HISTORIC AND DESIGN REVIEW COMMISSION

September 20, 2023

HDRC CASE NO: 2023-343
COMMON NAME: 958 E SOUTHCROSS
ADDRESS: 2900 ROOSEVELT AVE
2901 ROOSEVELT AVE
2835 ROOSEVELT AVE
1018 E SOUTHCROSS BLVD
992 E SOUTHCROSS BLVD
LEGAL DESCRIPTION: NCB 7674 BLK E LOT E PT & MID PT OF TR-1
NCB 7674 BLK C LOT W PT OF 1R & 2A EXC NE TRI 50 FT X 90 FT
NCB 7665 SE IRR 153.6 FT OF NE IRR 211.3 FT OF SW 503.6 FT OF 12
& N TRI 73.67 FT OF
NCB 7665 (ICP INDUSTRIES SUBD), LOT 39
NCB 8628 BLK LOT 3 (PICKUP INC SUBDIVISION)
NCB 7665 BLK LOT 16
ZONING: MXD, H, RIO-5
CITY COUNCIL DIST.: 3
DISTRICT: Mission Historic District
APPLICANT: Michael Clancy/Alamo Architects
OWNER: James Lifshutz/TEXAS HOME MORTGAGE INC
TYPE OF WORK: Construction of a mixed-use development with multiple structures, site and landscaping modifications
APPLICATION RECEIVED: August 18, 2023
60-DAY REVIEW: October 17, 2023
CASE MANAGER: Edward Hall
REQUEST:

San Jose Village

Site Plan - Not to Scale

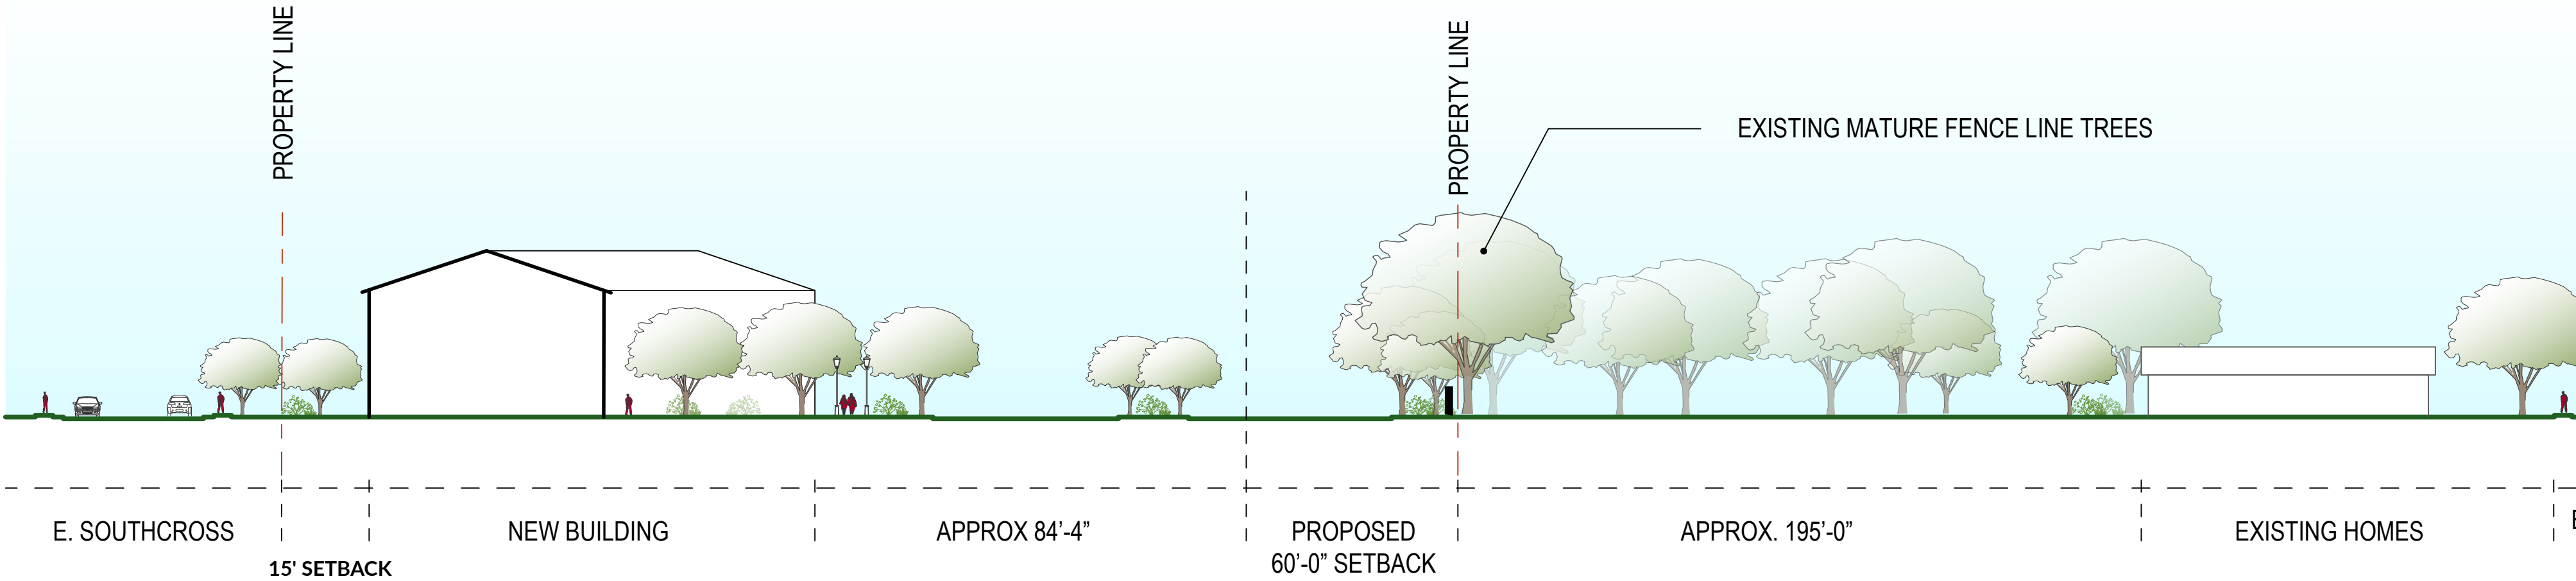
with primary façade that address external views from the public right of way as well as create comfortable interior spaces such as courtyards and circulation spaces. Staff finds that buildings have been arranged in a campus-like setting; however, staff finds that additional landscaping elements should be added within void spaces between buildings to accommodate additional courtyard space. Currently, the majority of void spaces between buildings is accommodating automobile parking.

- t. **PARKING LOTS** – The applicant has proposed to perform site modifications to include the construction of surface parking lots, site paving and various landscaped areas. The applicant has proposed surface parking throughout the site, primarily to the sides and rear of proposed new construction. Per the Mission Historic District Design Manual 4.C., parking area should be located behind buildings within urban historic contexts. Parking areas with ten (10) or more spaces located in the side and rear yards shall be interrupted with landscaped areas (pods) at a ratio of sixteen point two (16.2) square feet landscaped area for every one (1) vehicle parking spot. Pods may be used to meet the requirement for tree and understory preservation, parking lot canopy trees and/or pedestrian circulation system. Canopy trees shall be integrated into the design of surface parking lots to provide shade for a minimum of 25 percent of any individual parking lot. Additionally, the Mission Historic District Design Manual recommends screening of parking areas from the sidewalk and street with a landscaping buffer to reduce its overall visual impact. Staff finds that all landscaping requirements of the Mission Manual should be met and that the applicant should explore ways to further screen and buffer parking from view of pedestrian traffic and the public right of way. The applicant has noted a total of 26,644 square feet of planting. The requirement per the Mission Manual is 12,053.

- ii. That additional landscaping elements should be added within void spaces between buildings to accommodate additional courtyard space, as noted in finding h. Currently, the majority of void spaces between buildings is accommodating automobile parking.

- iii. That all landscaping requirements of the Mission Manual should be met and that the applicant should explore ways to further screen and buffer parking from view of pedestrian traffic and the public right of way. Canopy trees should be planted to shade at least twenty-five (25) percent of any individual parking lot.

Preliminary Building Elevations

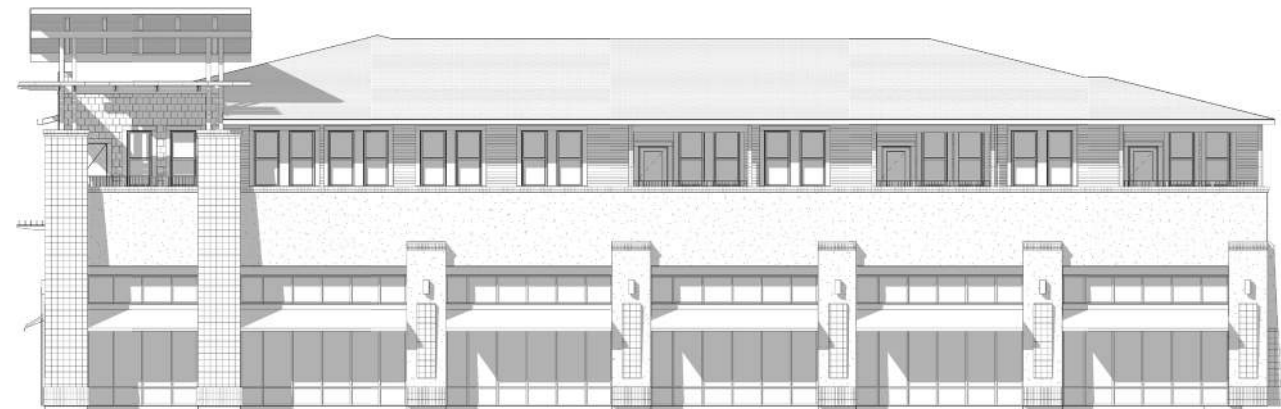
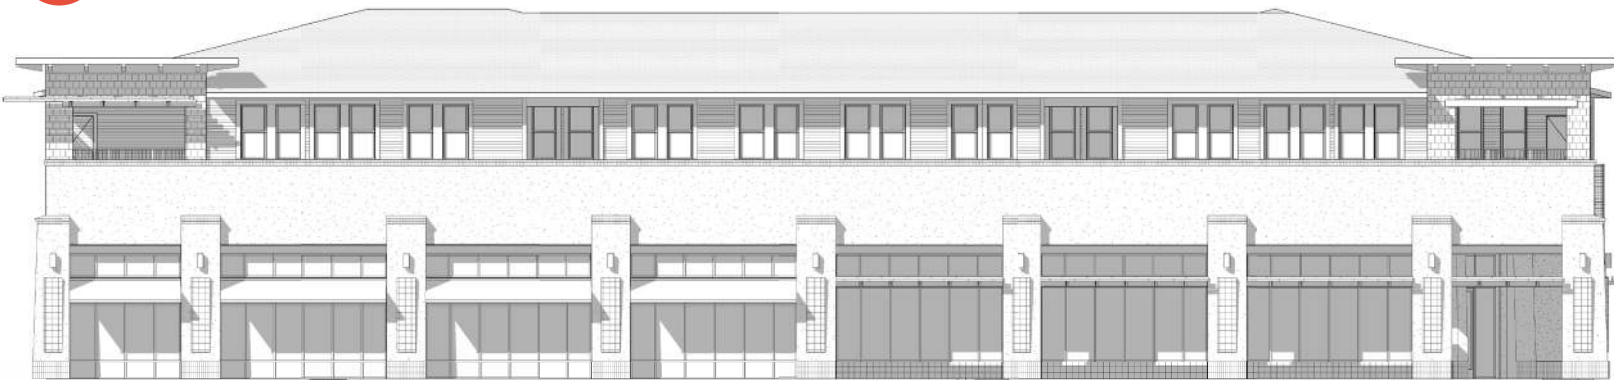
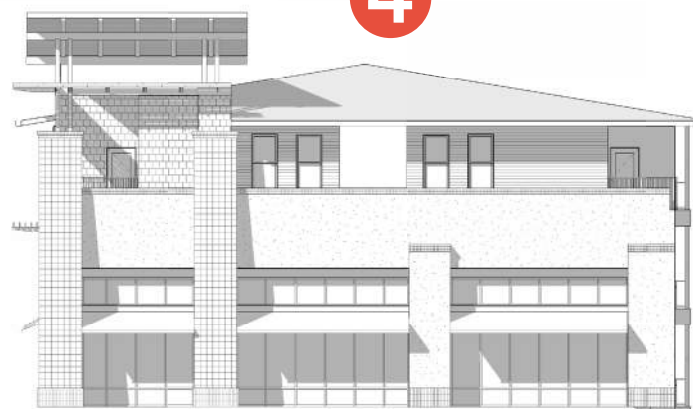
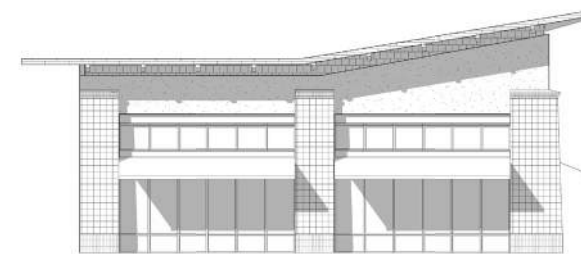
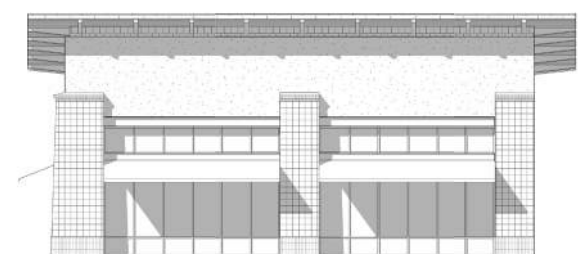
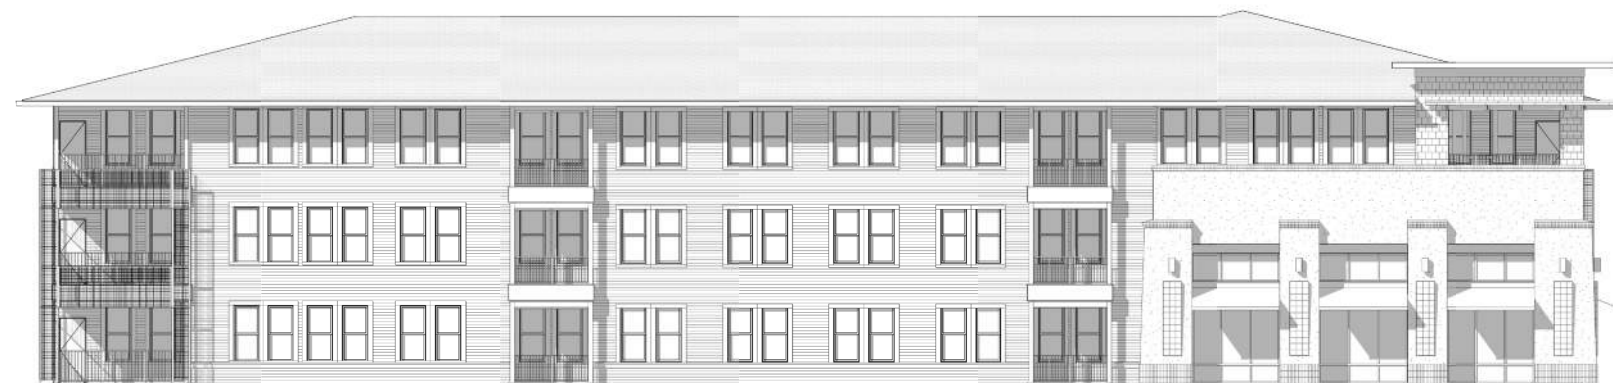
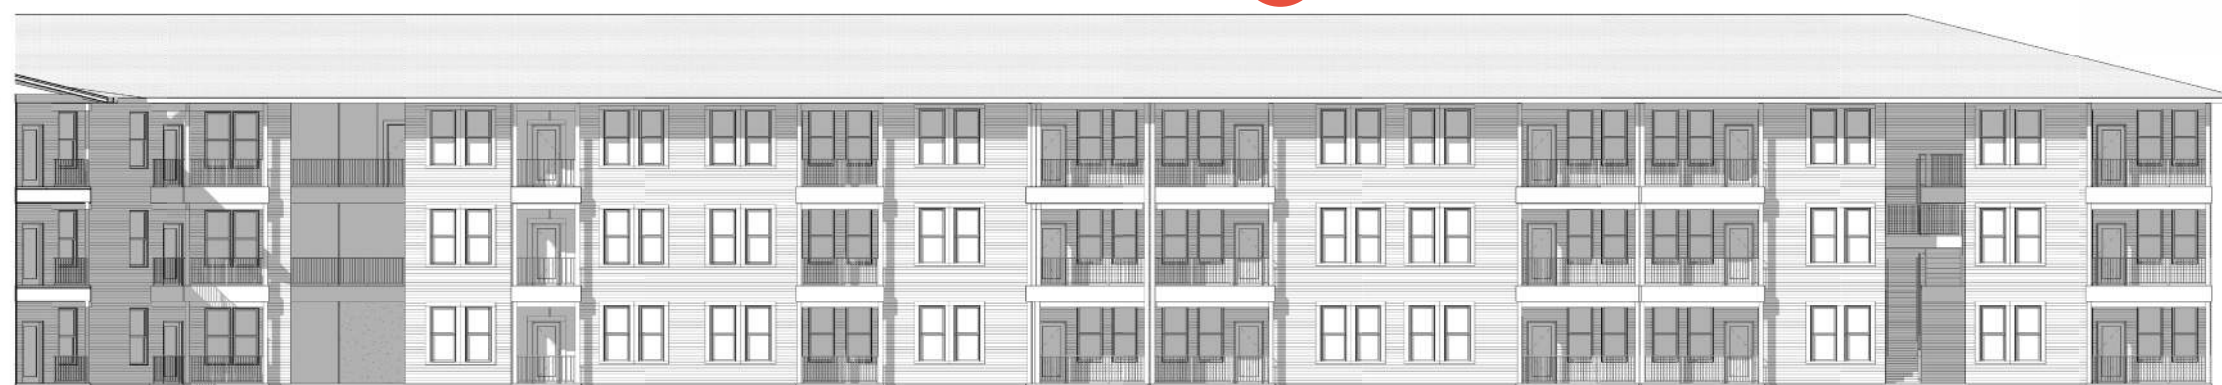
- m. **FAÇADE LENGTH** – The Mission Historic District Design Manual 2.B.ii. notes that commercial structures should not include uninterrupted wall planes of more than fifty (50) feet in length. Building facades may utilize an offset, substantial change in materials, or change in building height in order to articulate individual wall planes. The applicant has demonstrated compliance with the Mission Manual requirements for façade separation based on the preliminary elevations and perspectives that have been submitted.

- o. **ROOF FORMS** – The Mission Historic District Design Manual 2.C. notes that flat roofs with parapet walls is recommended as a primary roof form for all commercial buildings. The Mission Manual notes that secondary roof forms should utilize traditional forms such as hipped or gabled roof forms and should establish a uniform language that is subordinate to the primary roof form. The applicant has not provided roof plans at this time; however, the applicant has provided preliminary building elevations noting large, hipped roof forms for the primary roof forms for two of the proposed structures. This is not consistent with the Mission Manual. Staff finds that roof forms that are consistent with the Mission Manual should be used. Additionally, per the Mission Manual, where roof forms with ridge lines are used, uniform ridge heights should be used. As currently proposed, the ridge heights vary. This is not consistent with the Mission Manual. The applicant has noted that

the hipped roofs are evident in elevation, but are low sloped and will not be immediately perceived from ground level.

- v. That the applicant explores ways to reduce the slopes of all hipped roofs to reduce their perceived massing.
- vi. That every attempt be made to meet the standards for windows in new construction regarding installation profile and color.

HEAD - FRAMED WINDOW @ SIDING

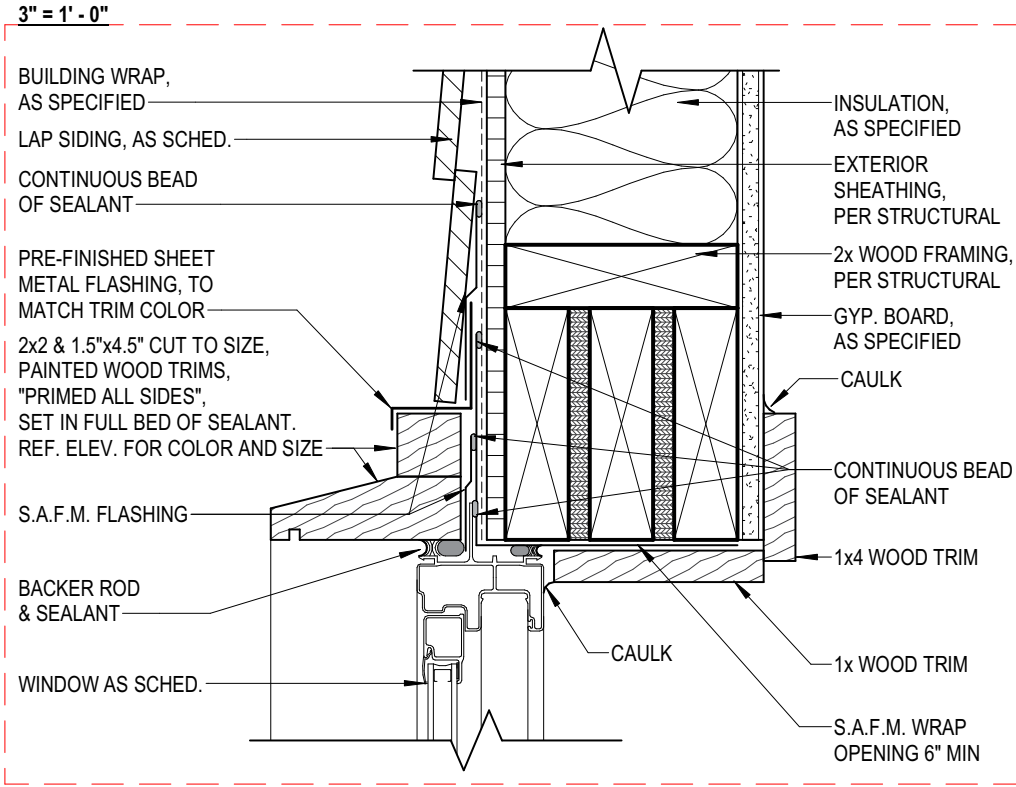
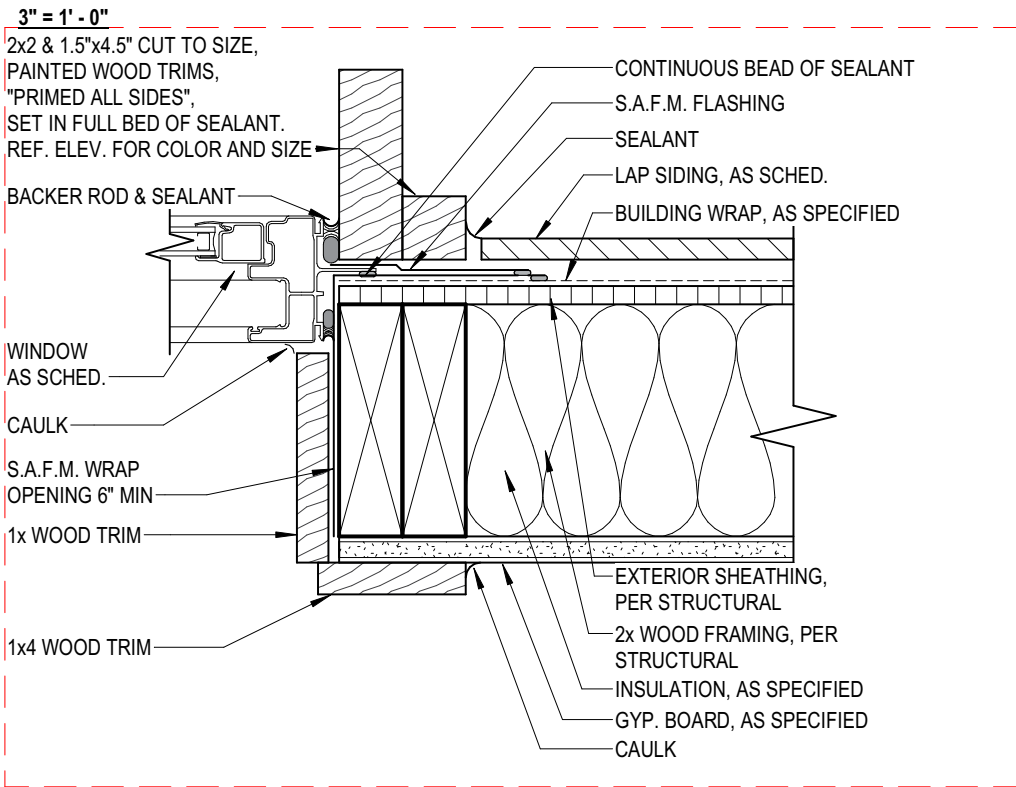
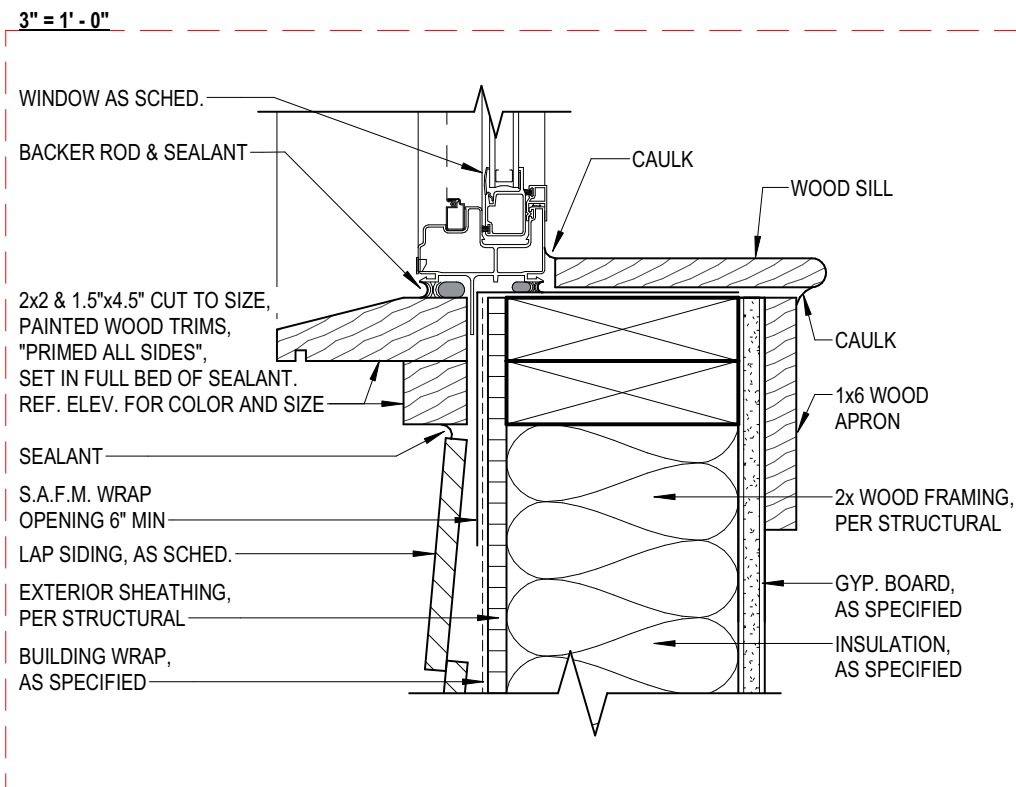
- r. **WINDOWS** – The Mission Historic District Design Manual 2.E.iii. notes that windows should be recessed into the façade by a minimum of two (2) inches and should feature profiles that are found historically within the Mission Historic District. Additionally, wood or aluminum clad wood windows are recommended. Other window materials may be appropriate provided they show consistency with staff's standard specifications for windows in new construction. Per the submitted application documents, the applicant has proposed windows generally appear consistent with the Mission Manual as they feature traditional, one over one profiles, in residential spaces. In commercial or mixed-use spaces, windows and fenestration feature profiles found more consistently in existing and historic commercial structures in the immediate vicinity and throughout the district. The applicant has proposed a bronzed color, single-hung vinyl window. The proposed window will feature a nailing fin. The applicant has noted a 2 inch window trim reveal detail for public facing residential spaces. For interior or rear facing residential spaces, the applicant has proposed no window recess/reveal. Staff finds that every attempt should be made to meet the standards for windows in new construction.
